Planning Commission Regular Meeting

Monday, November 24, 2025, 6:30 PM
106 Center Street

ITEM REPORT**To:** Planning Commission**From:** Julia Mullin, Community Development Director**Meeting Date:** November 24, 2025**Department/Office:** Community Development**Item Name:** 174 West Lake Street Residential Review Permit and Variance Applications (PC No. 2025-09) - *continued from 11/10/2025 Planning Commission meeting***Summary:**

site plan diagram

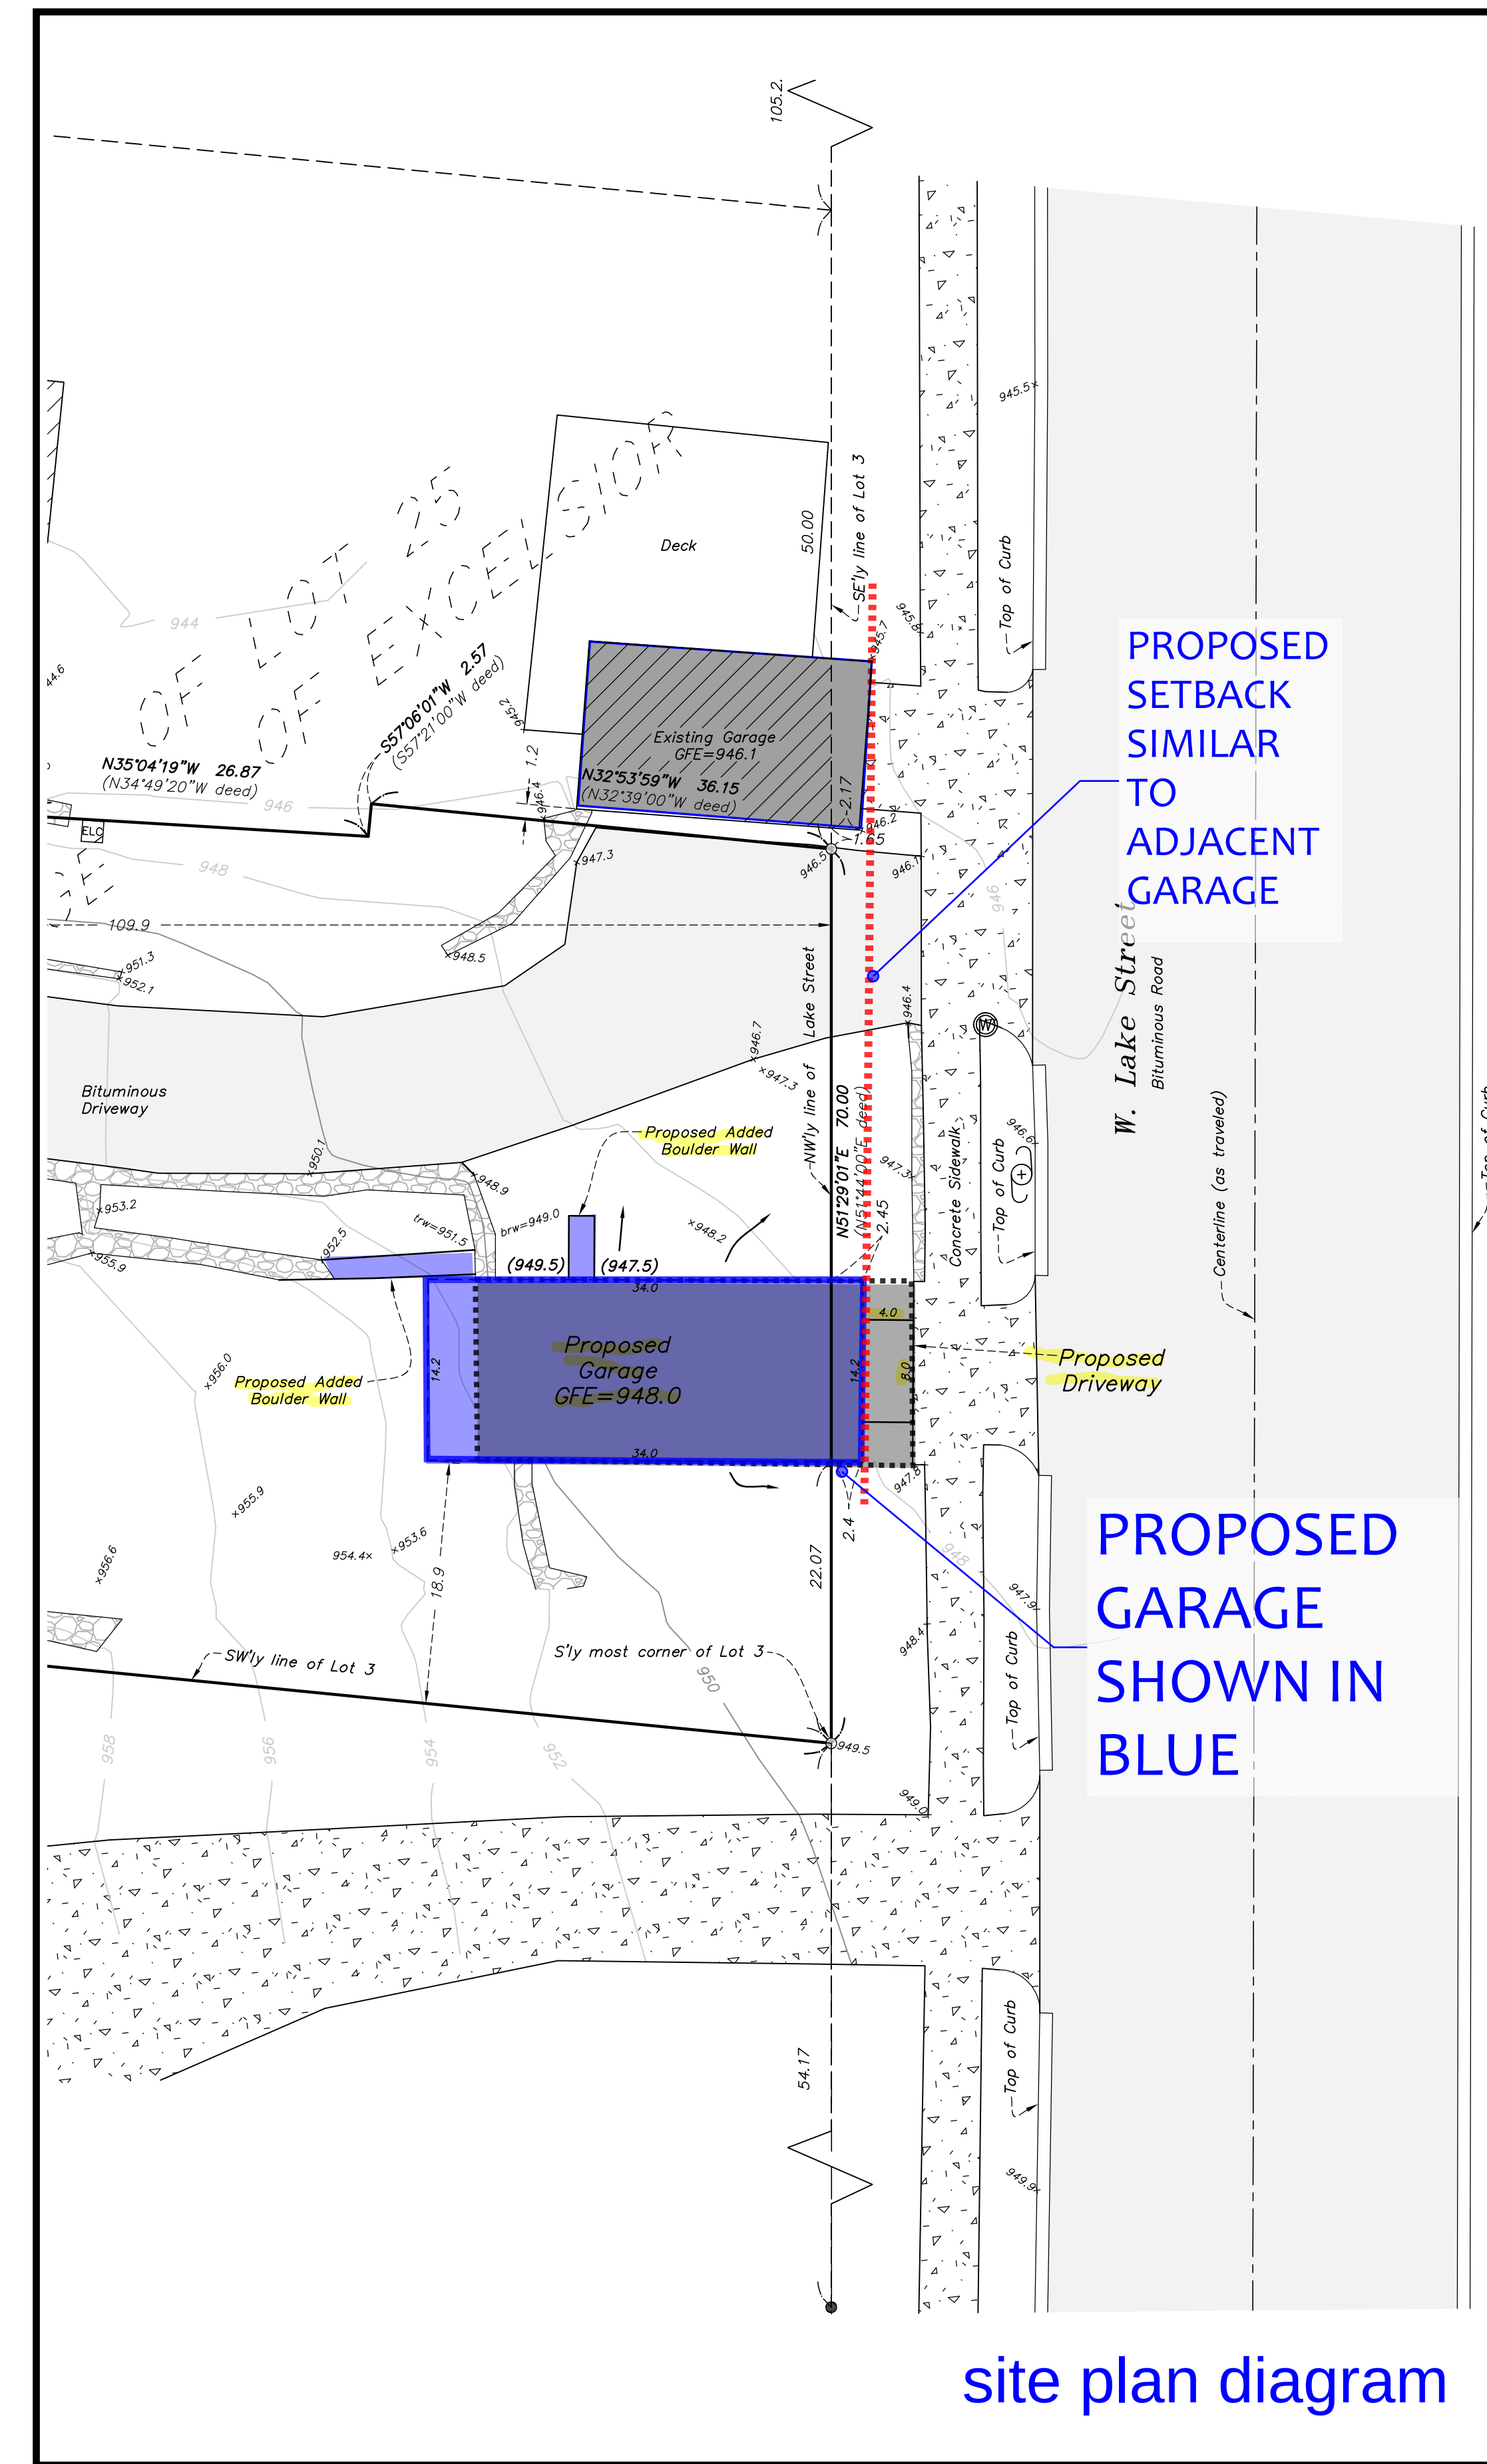
The proposed garage is comparable in massing and scale to neighboring structures on West Lake Street. The applicant has included dormers to the roof to break up the roof line and add architectural interest to the building. There is a detached garage at 162 West Lake Street with a partial second level, adjacent to the subject garage, and on the other abutting parcel there is no structure. The detached garage at 200 West Lake Street, four parcels to the southwest, is two stories.

The garage and retaining walls as proposed respond to the existing slopes. Some existing boulder retaining walls have been removed, and two small segments have been added to accommodate the relocation of the garage footprint and its side entrance.

(approximately)
TWO-STORY
HOUSES
shown in **BLUE**

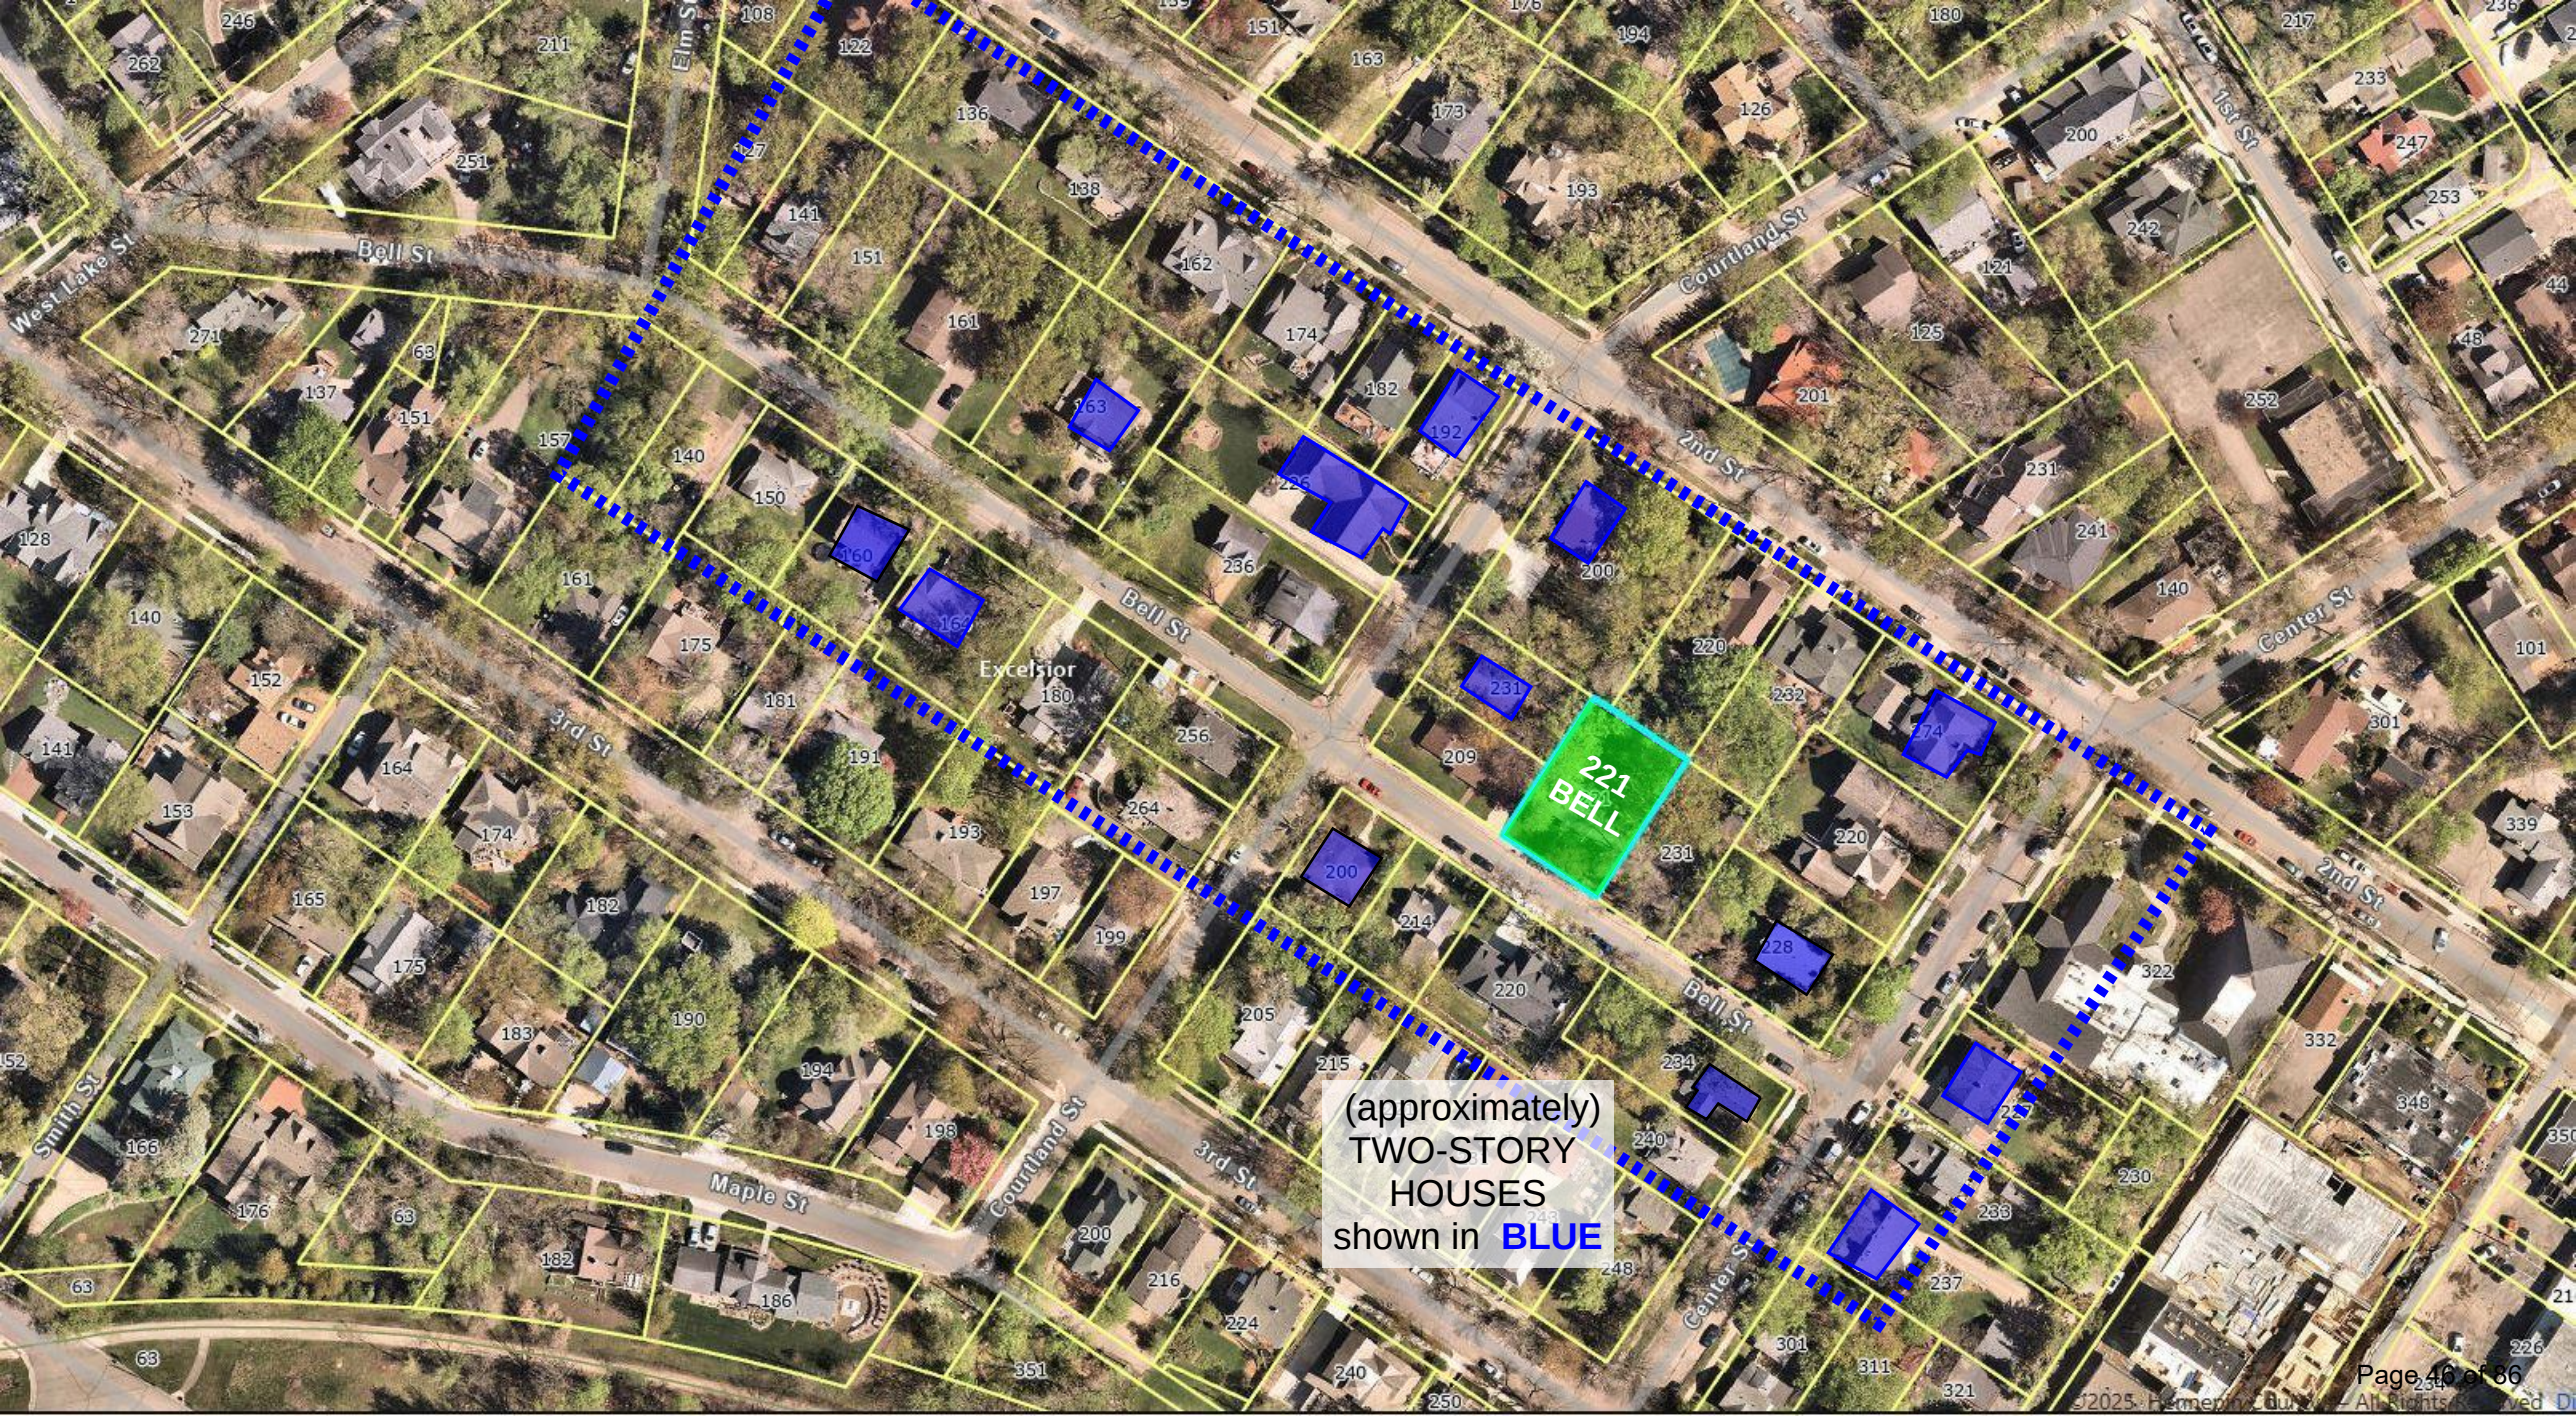
At two stories, the house will have an effect on neighbors, but setting back the second story at the right (at closest neighboring house) indicates design consideration. By mostly using the existing house footprint and not maximizing lot coverage, the impact on neighbors is also lessened.
